# MEMPHIS STONE AND GRAVEL CO.

**RE: NPDES Application  
Memphis Stone and Gravel Company  
Atoka Aggregate Facility  
Proposed NPDES Permit TN0079821**

Memphis Stone and Gravel Company (MS&G) submits this letter in response to your comments described in a letter dated July 24, 2007 (certified mail 70062760000283240584). Outlined below are your specific comments and following them are our responses.

Memphis Stone & Gravel Company  
Mine Area Identification Map  
Atoka Aggregate Facility  
NPDES Application  
Tipton County, TN  
March 1, 2007 AGP

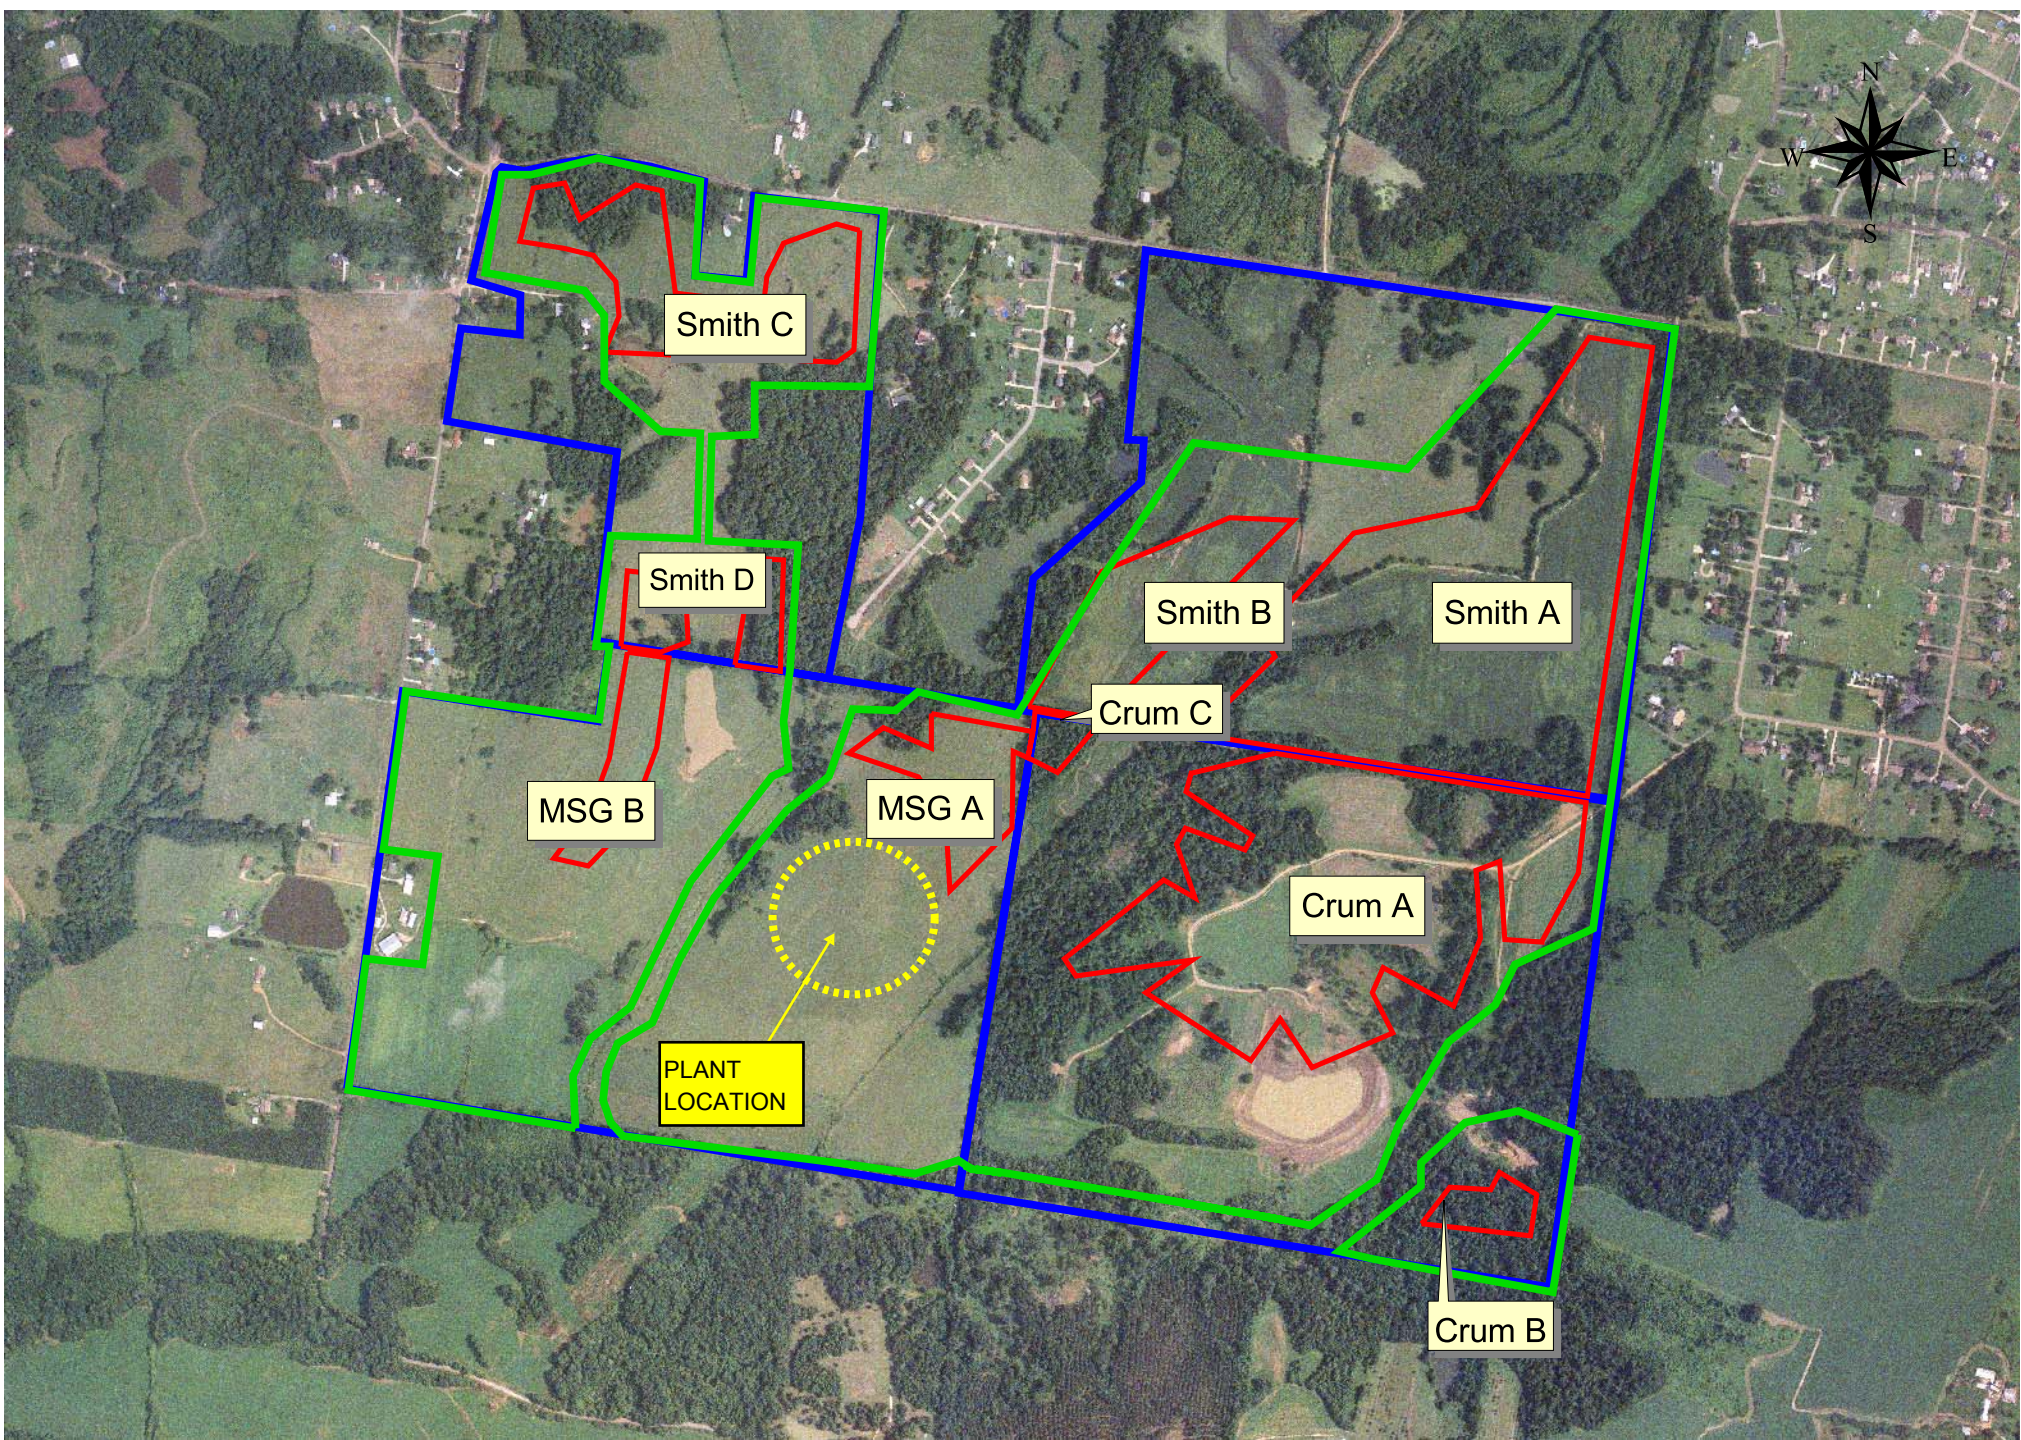
On either the Site Drainage Maps or the Location Map, more clearly label the process plant site, and Areas A, B, C, etc., within each of the different land areas (Crum, Smith, and MS&G).

A new location map illustrating these areas is enclosed.

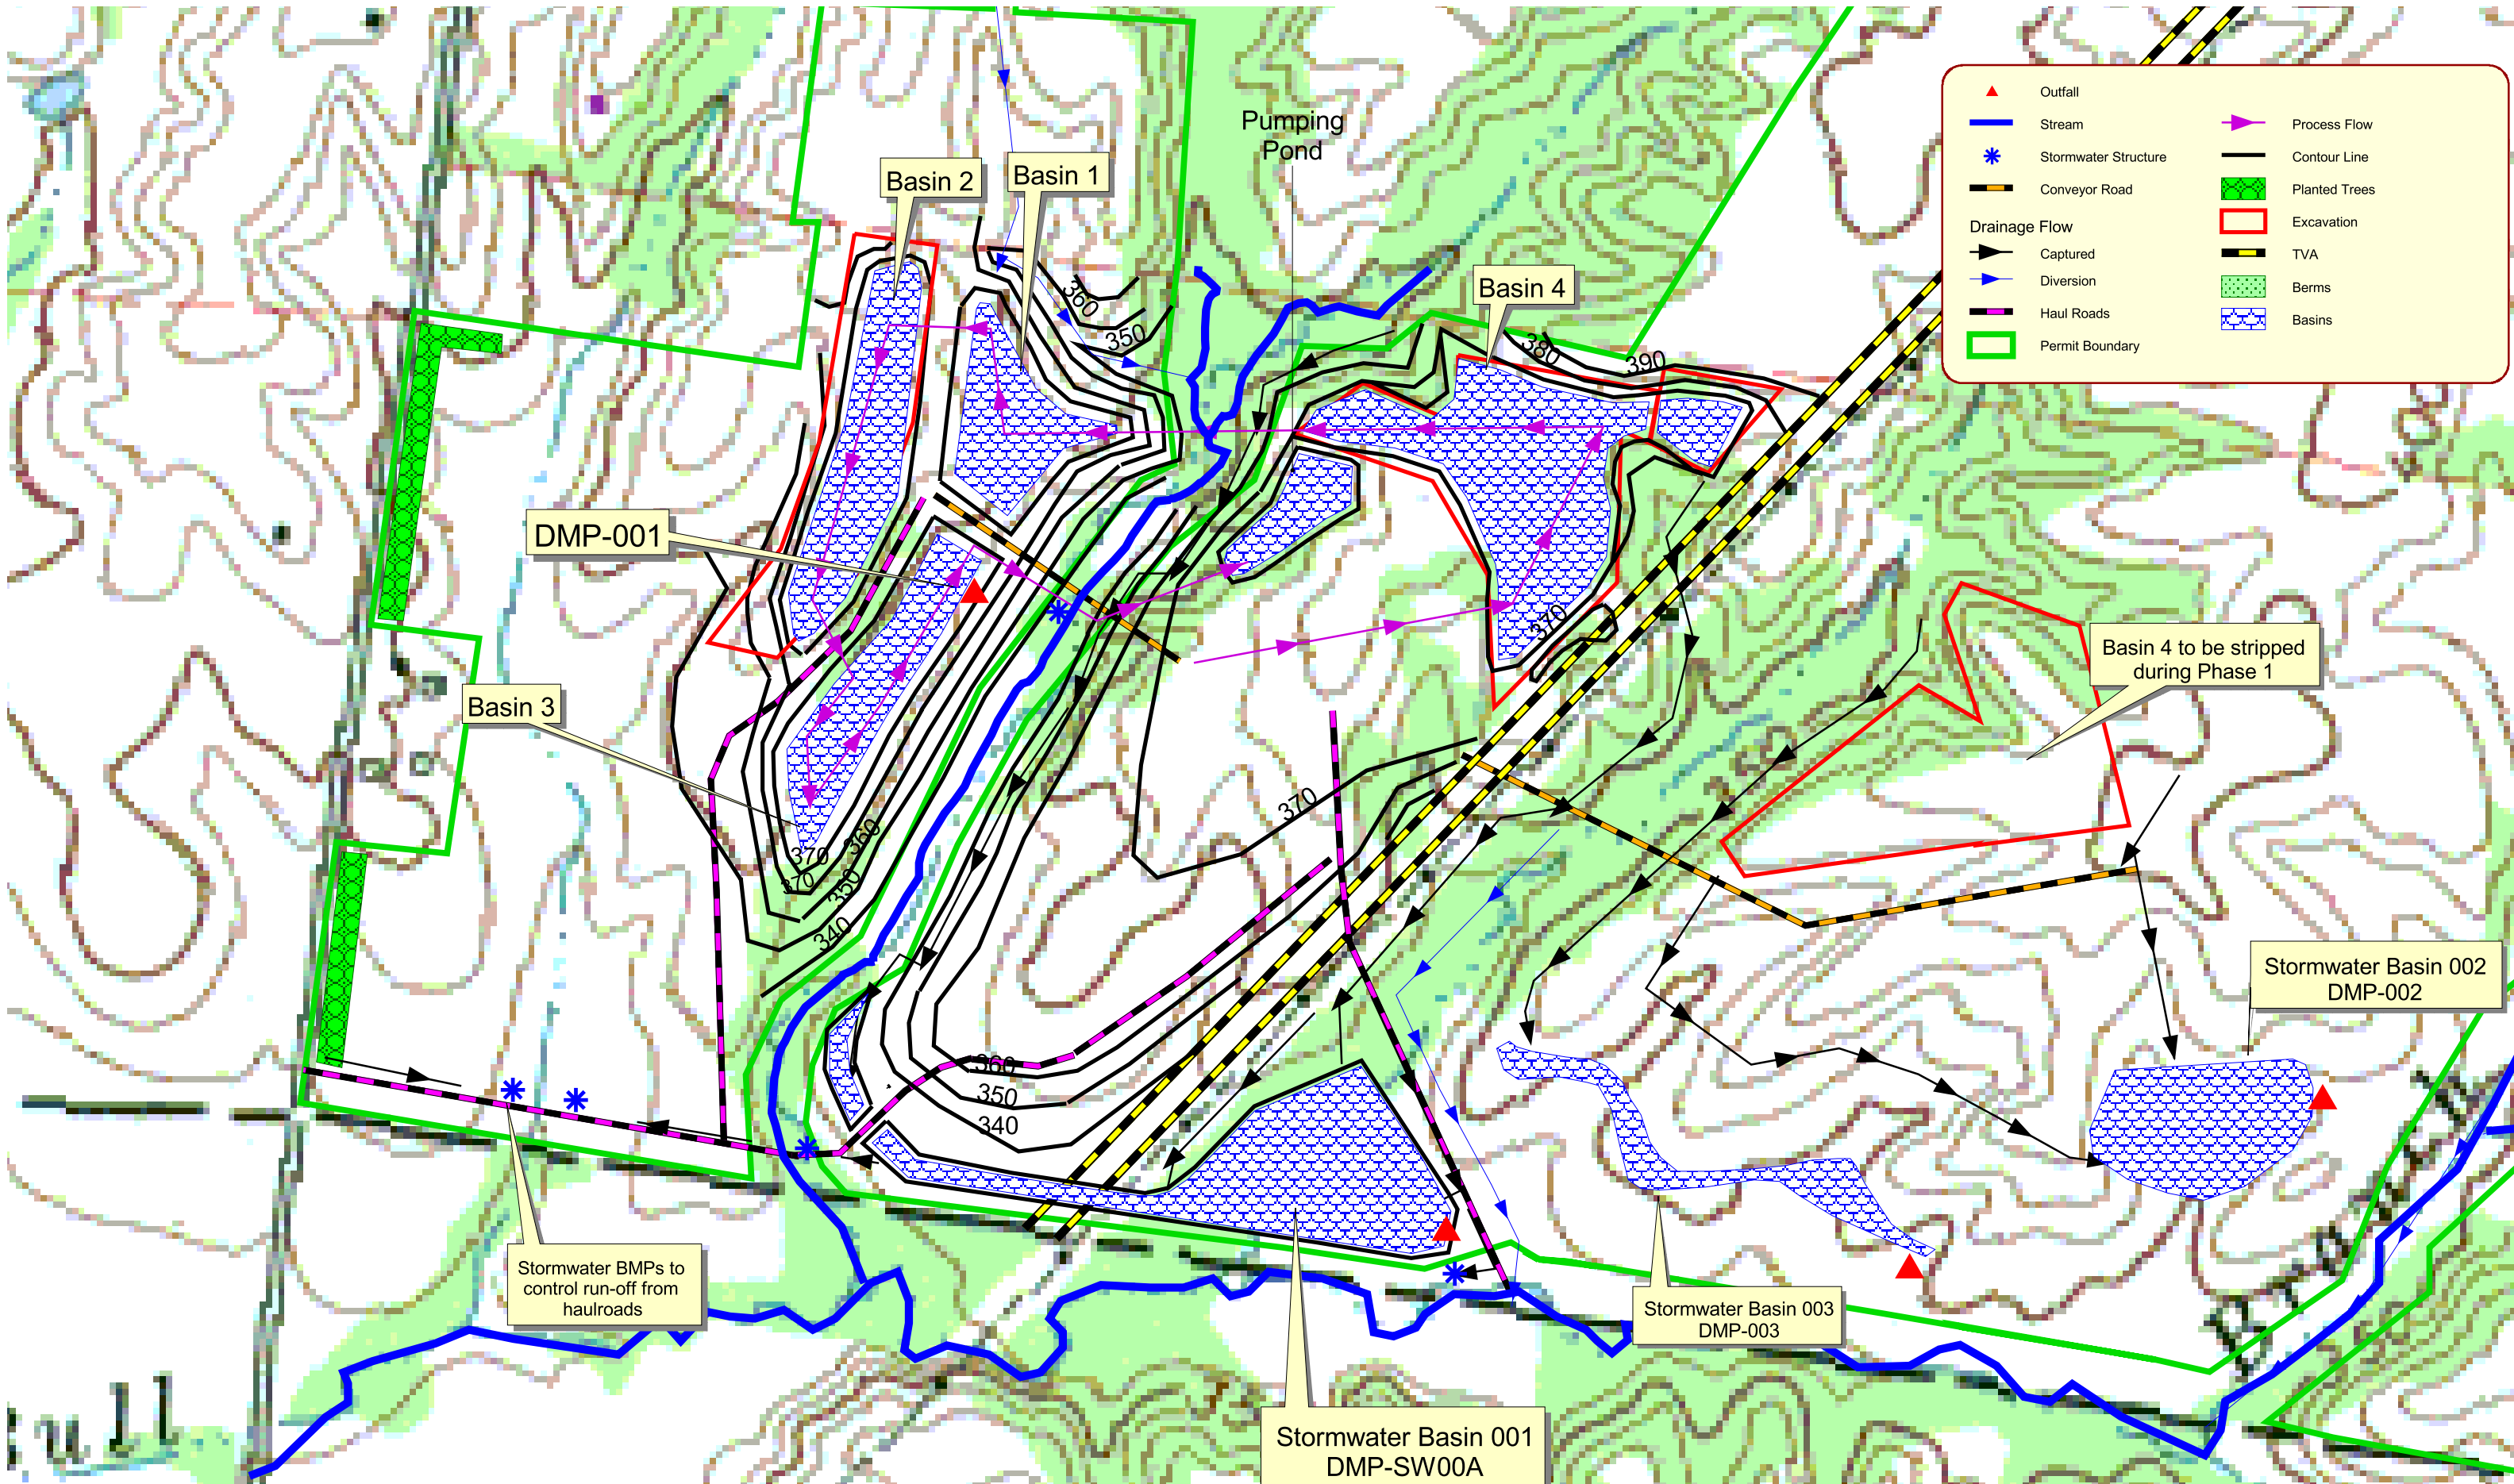
The location of Monitoring Point 001 within Process Basin 3 is inconsistently shown on the *Drainage Management Plan Maps* for Phases 1, 2, and 3. In Phase 1, the outfall is in the northeast corner, in Phase 2 it's in the southeast corner, and then in Phase 3 it is shown to the east of the northeast corner of the basin. Please explain why the outfall changes locations or revise the maps to show the outfall in the same place.

The application states that water from Stormwater Basin 001 will be pumped to the Process Basins. However, even though treated water from this basin will be pumped to the process plant, a monitoring point should be added at the emergency spillway in the instance there is a discharge. Please revise the EPA form 2D, the water flow diagram, drainage plan narrative, and maps as necessary to include this new discharge monitoring point.

The inconsistent location of Monitoring Point 001 was an oversight when the maps were redrawn for the revised application. DMP-001 should remain at the same location for the life of the project. New Drainage Management Plan Maps for Phases 1, 2, and 3 are enclosed.

MS&G will create a temporary DMP at the emergency spillway at Stormwater Basin 001. The DMP will be SW-00A. The appropriate revisions to EPA form 2D, the water flow diagram, narrative, and maps have been made and are enclosed.
